North Dakota Department of Transportation

ADDENDUM 1 – JOB 23

TO: All prospective bidders on project NH-NHU-4-083(111)200, Job No. 23 scheduled for the November 18, 2016 bid opening.

Project Information		
Project: NH-NHU-4-083(111)200		PCN: 18912
Location: Minot, Ward County		
Date:10/14/16		Lead Designer: Burns & McDonnell
Bid Opening Date: 11/18/16		JOB#: 23 Addendum#: 1
Distribute to: -Grp-DOT Bids Addenda (dotbids@nd.gov)		
Section	Sheet	Description of Change
2	1	<ul style="list-style-type: none"> Deleted Section 85 Landscaping Added Section 130 Guardrail Updated Section 6 (page 1-5 Notes and page 6 Environmental Notes) Added SP 0386(14) Removed SP 0363(14)
2	2	<ul style="list-style-type: none"> Added Guardrail Standard Drawings D764-1,5,22
4	1	<ul style="list-style-type: none"> Updated extents of imprinted concrete Removed sidewalk South of the bridge, West of US-83 Updated edge of pavement due to guardrail addition
6	ALL	<ul style="list-style-type: none"> Updated plan note on 100-P01 to include coordinating use of Temporary Construction Easement between projects Added additional details/updates to 105-P02 Adding 105-P02 shifted all other notes and all sheets had to be repr

Revised	10/14/2016	STATE	PROJECT NUMBER	SECTION NO.	SHEET NO.
		ND	NH-NHU-4-083(111)200	170	137

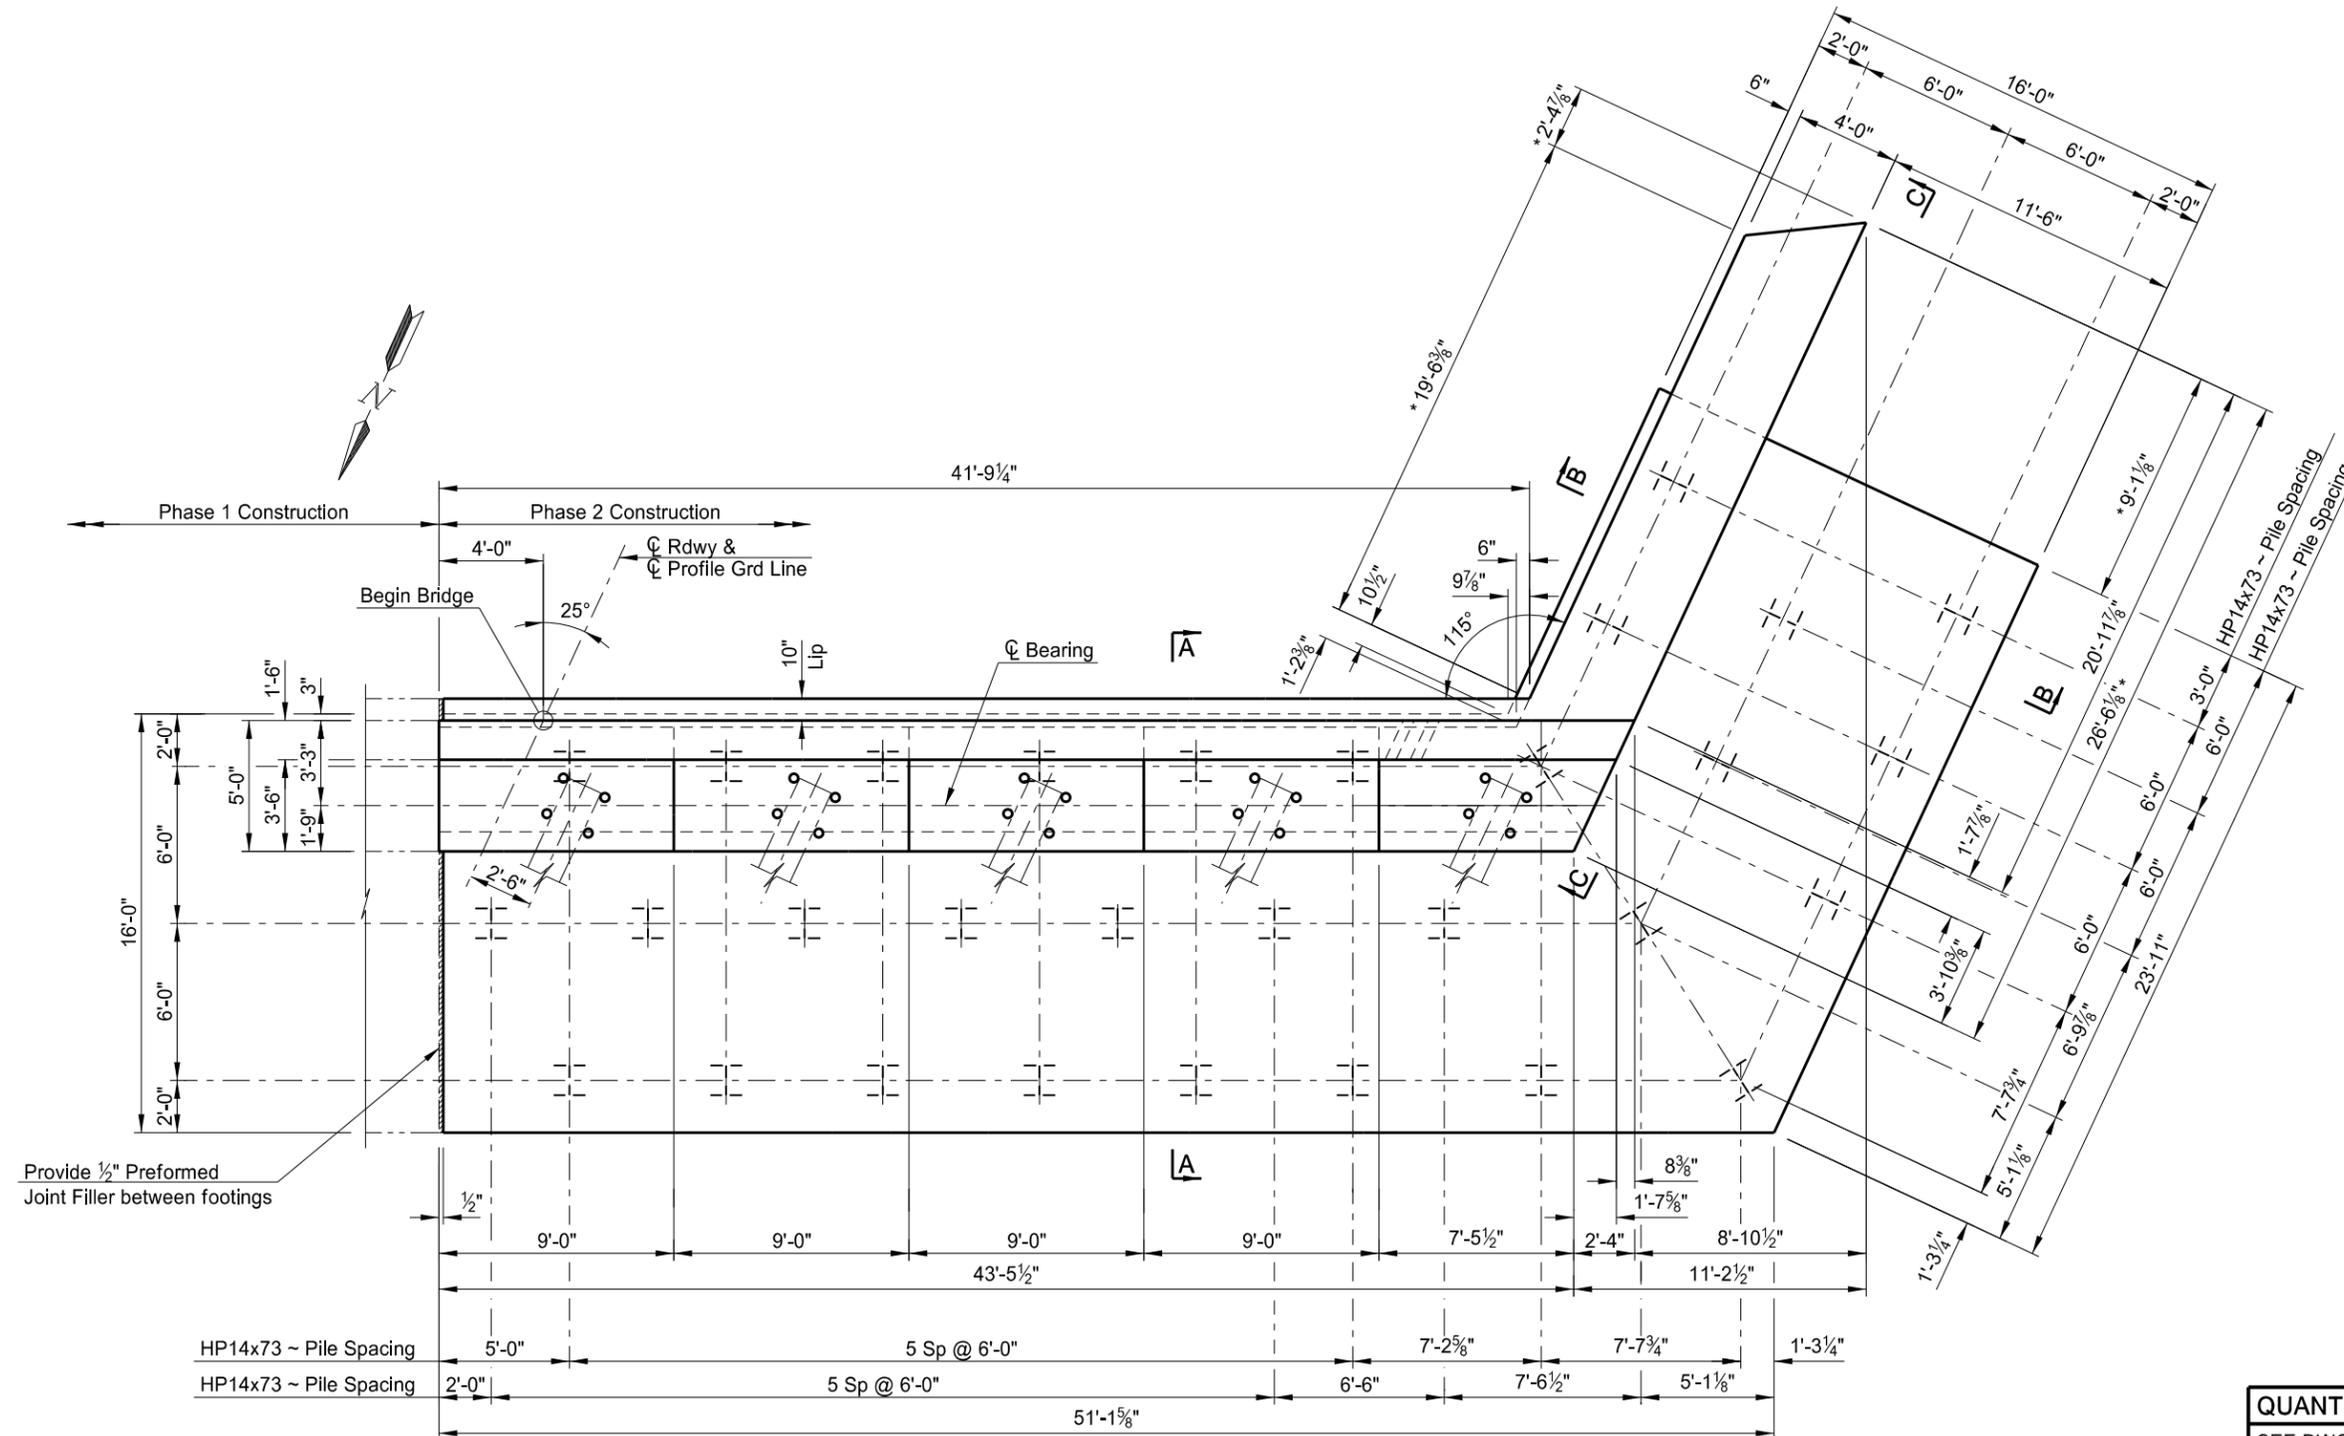
170	137	<ul style="list-style-type: none"> • Removed expansion joint
170	138	<ul style="list-style-type: none"> • Adjusted dimension to accommodate joint filler below approach slab
170	139	<ul style="list-style-type: none"> • Updated underdrain callouts to match PPG
170	140	<ul style="list-style-type: none"> • Removed old callout on underdrain pipe • Adjusted top of wall dimension
170	141	<ul style="list-style-type: none"> • Added threaded rebars
170	142	<ul style="list-style-type: none"> • Added threaded rebars
170	143	<ul style="list-style-type: none"> • Removed expansion joint; added threaded rebars
170	144	<ul style="list-style-type: none"> • Added threaded rebars
170	145	<ul style="list-style-type: none"> • Removed expansion joint; added threaded rebars
170	147	<ul style="list-style-type: none"> • Added Section A-A with corresponding section cut arrows
170	148	<ul style="list-style-type: none"> • Same as for NB

Revised 10/14/2016	STATE	PROJECT NUMBER	SECTION NO.	SHEET NO.
	ND	NH-NHU-4-083(111)200	170	197

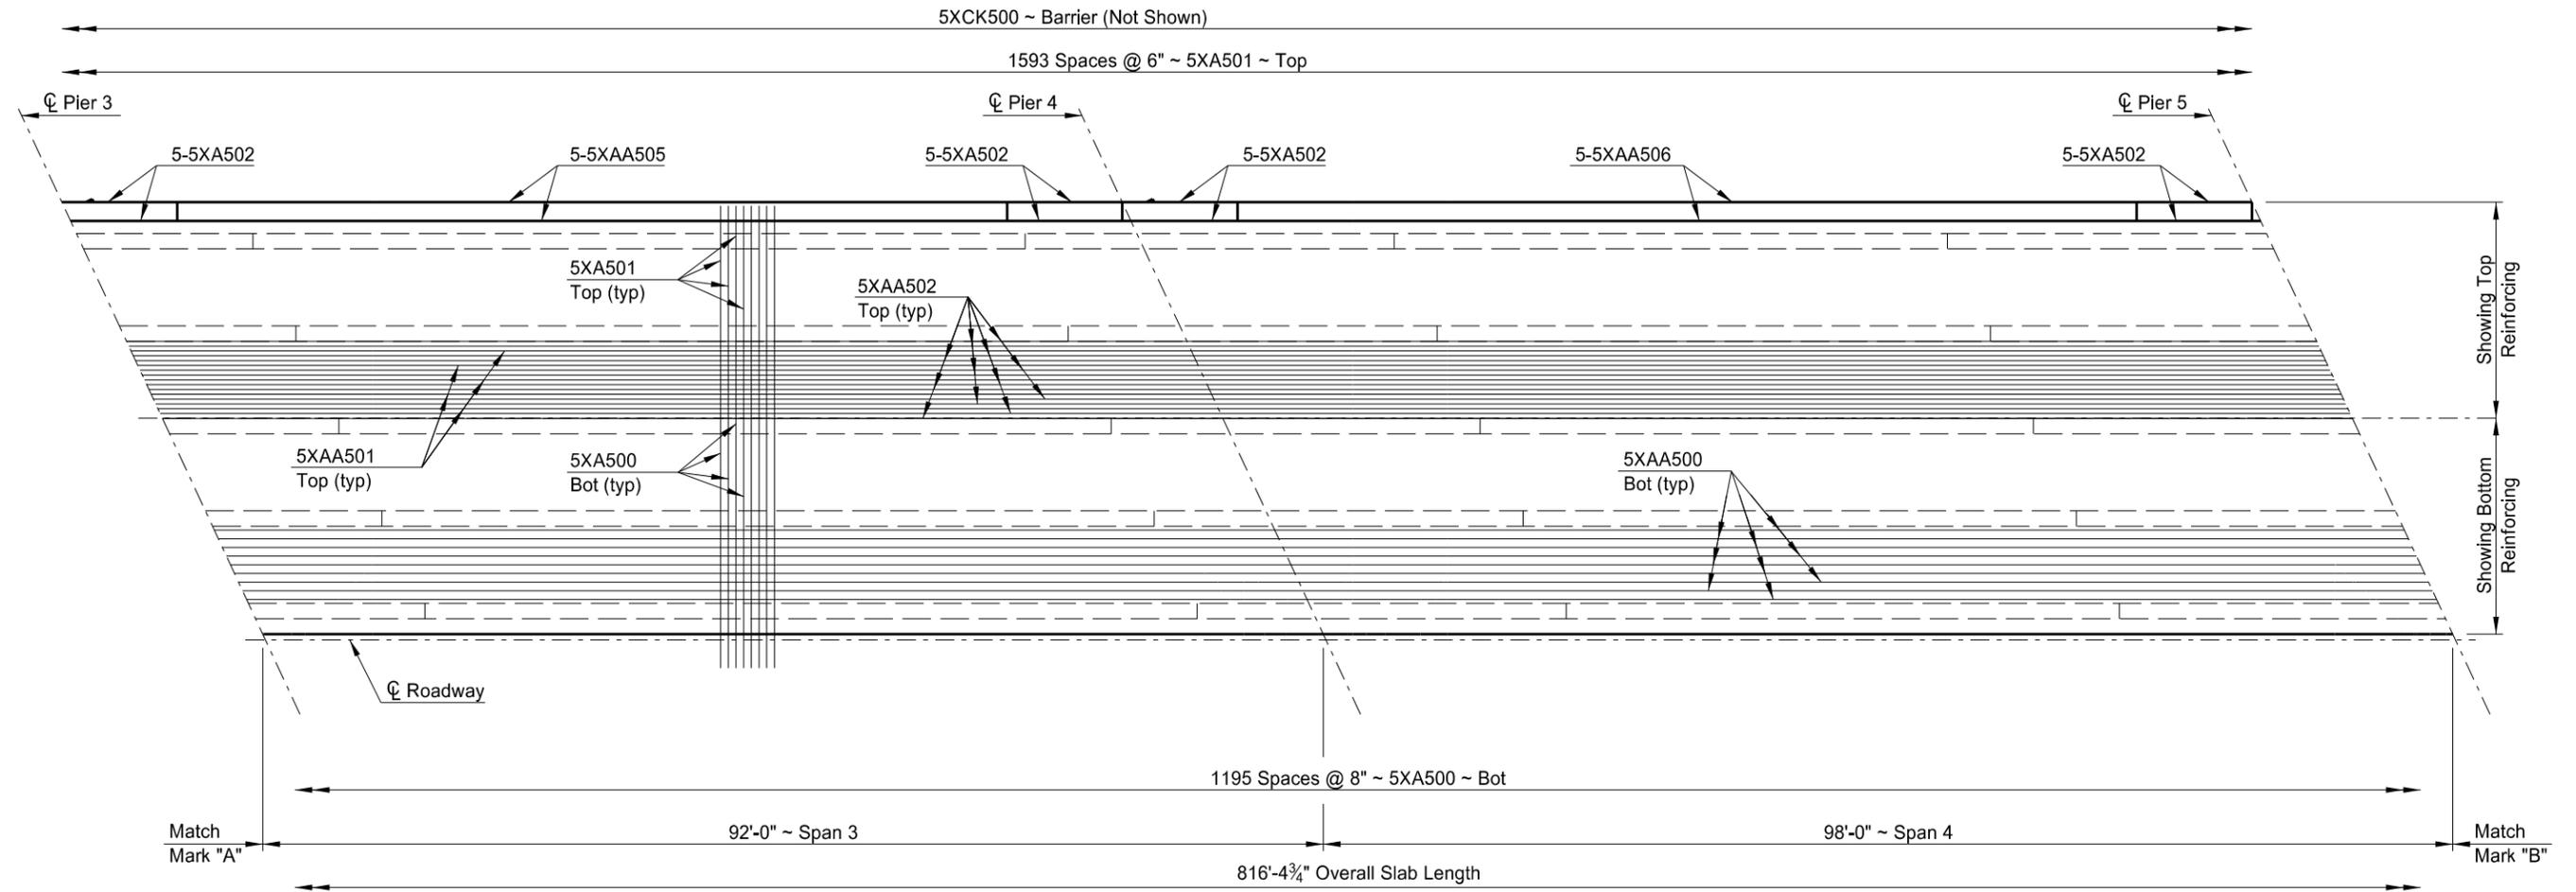
170	197	<ul style="list-style-type: none"> • Couplers added to transverse bars and note revised for these bars
170	198	<ul style="list-style-type: none"> • Couplers added to transverse bars and note revised for these bars

Revised 10/14/2016	STATE	PROJECT NUMBER	SECTION NO.	SHEET NO.
	ND	NH-NHU-4-083(111)200	170	199

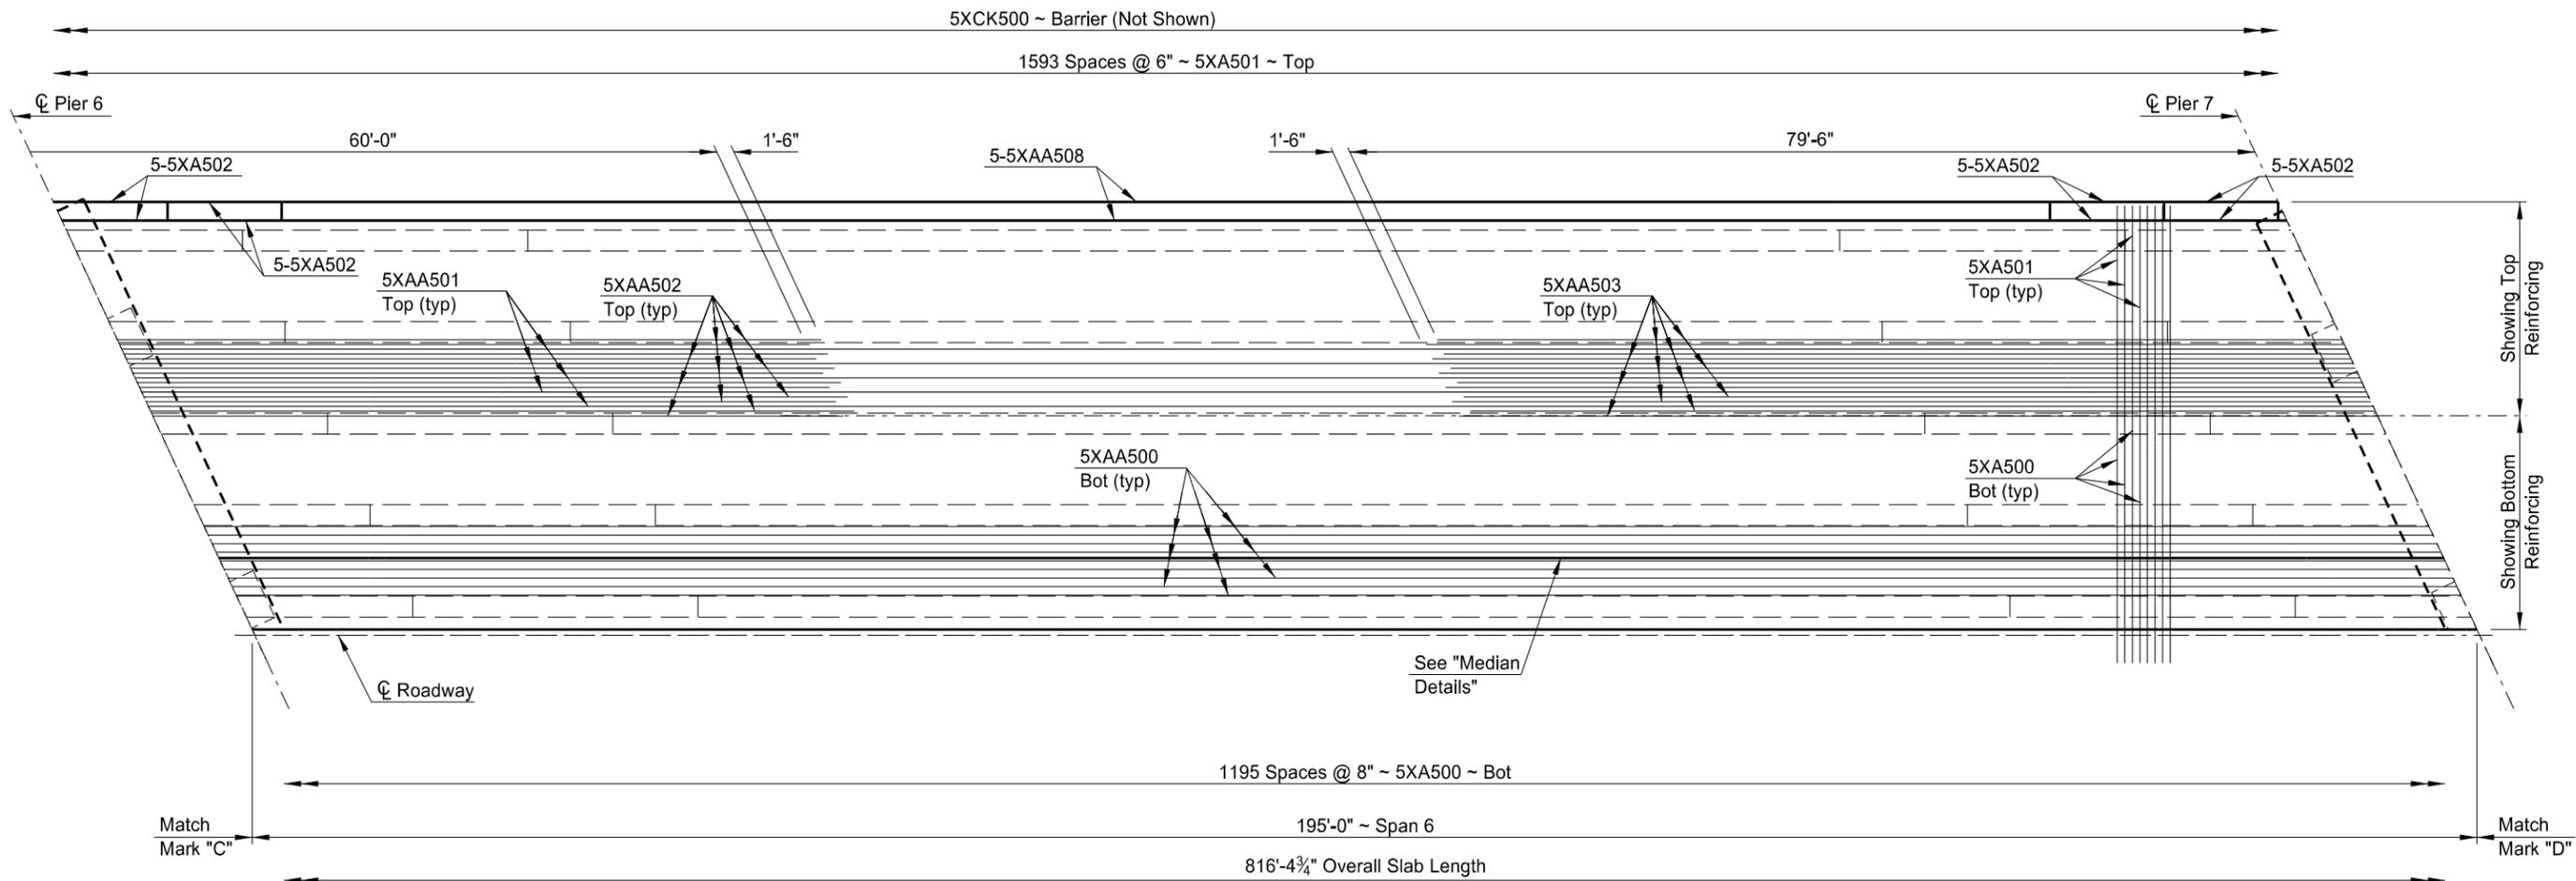
170	199	<ul style="list-style-type: none"> • Couplers added to transverse bars and note revised for these bars
170	200	<ul style="list-style-type: none"> • Added referencing notes
170	201	<ul style="list-style-type: none"> • Type 5 sealant callout removed
170	202	<ul style="list-style-type: none"> • Remove drip groove; couplers from phase 1 shown
170	203	<ul style="list-style-type: none"> • Added referencing call out • Changed barrier detail to section A-A and added rebar callout
170	204	<ul style="list-style-type: none"> • Added referencing call out • Changed barrier detail to section B-B and added rebar callout
170	205	<ul style="list-style-type: none"> • Added thrie beam connection; modified barrier shape
170	209	<ul style="list-style-type: none"> • Added median barrier callouts
170	210	<ul style="list-style-type: none"> • Changed median finish callouts
170	211	<ul style="list-style-type: none"> • Updated to reflect Abutment 8 rebar modifications • Added note
